# PENSHURST PUBLIC SCHOOL UPGRADE

## CIVIL ENGINEERING DRAWINGS

PERUMAL PENSHURST PUBLIC SCHOOL 18 Arcadia Street, Penshurst STANDARD NOTES

SCALE - @ A CHECKED 10 MAY 2019 Drawing Number Revision 3199 - CIV- CD- <mark>01 001</mark>

AND DRAWING LIST

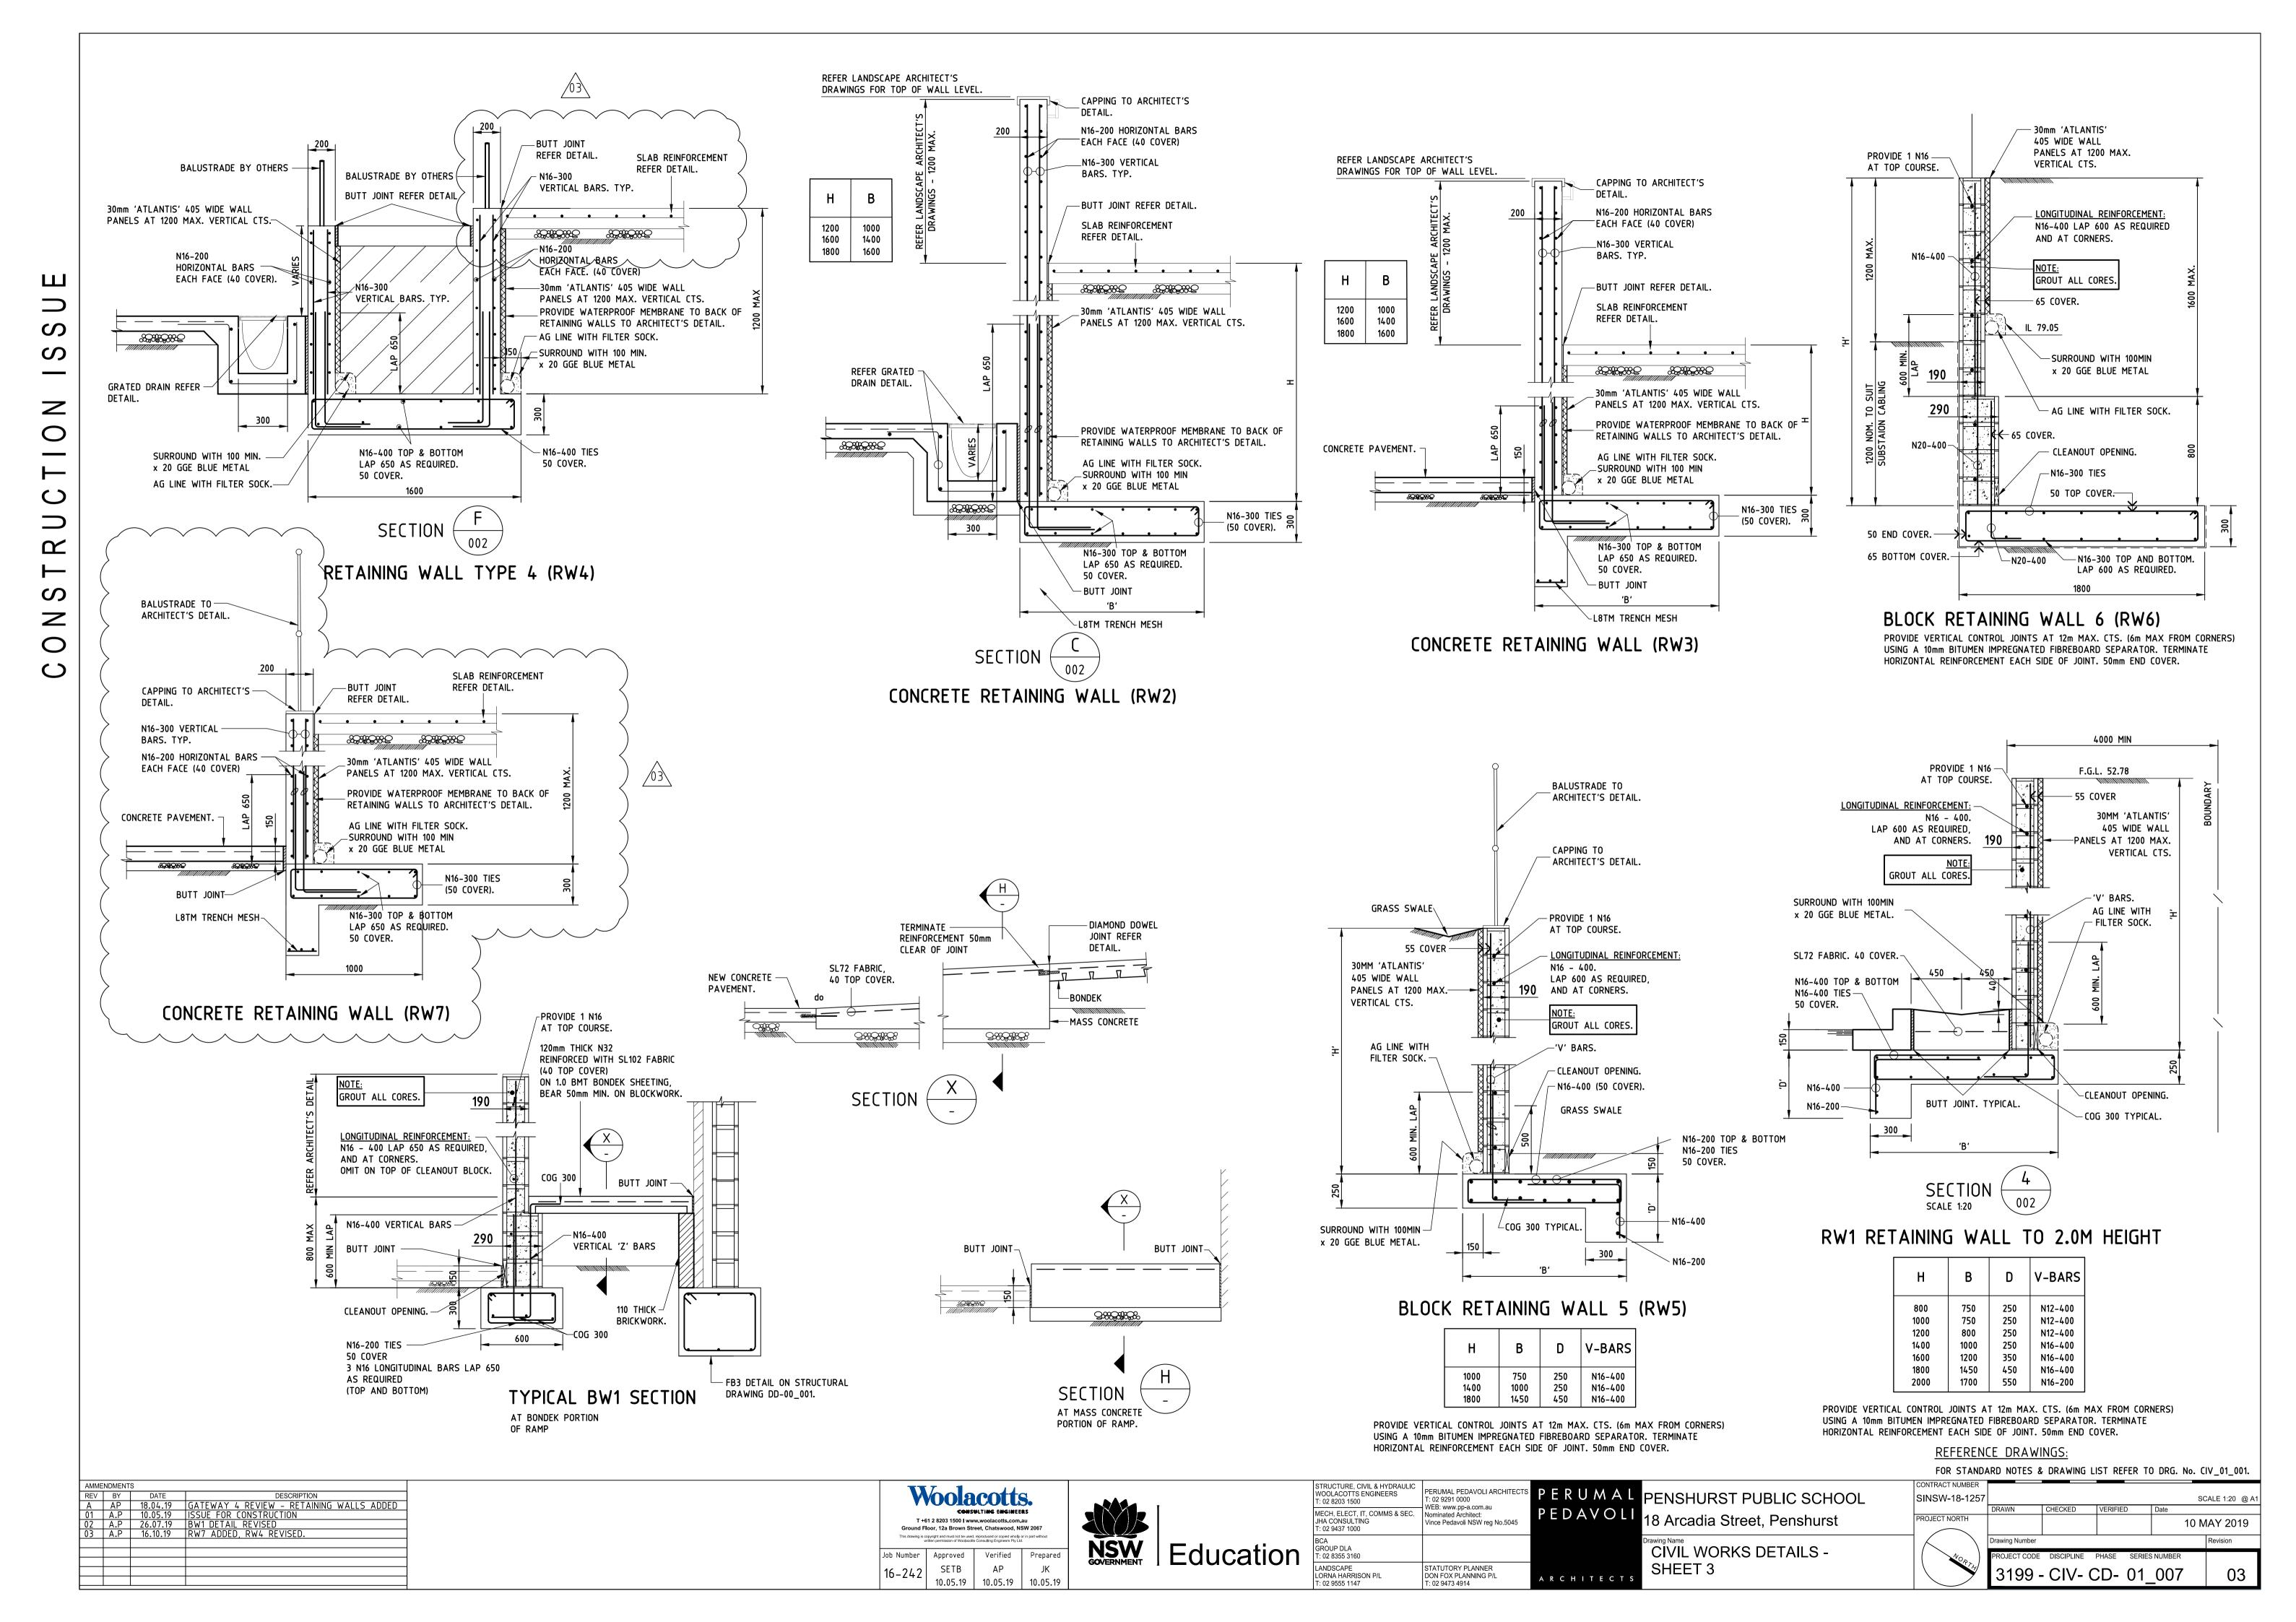
Thickness of pavement amended from 110mm to 125mm. WCE say they can go back to 110mm. Why did they change it in the first place?
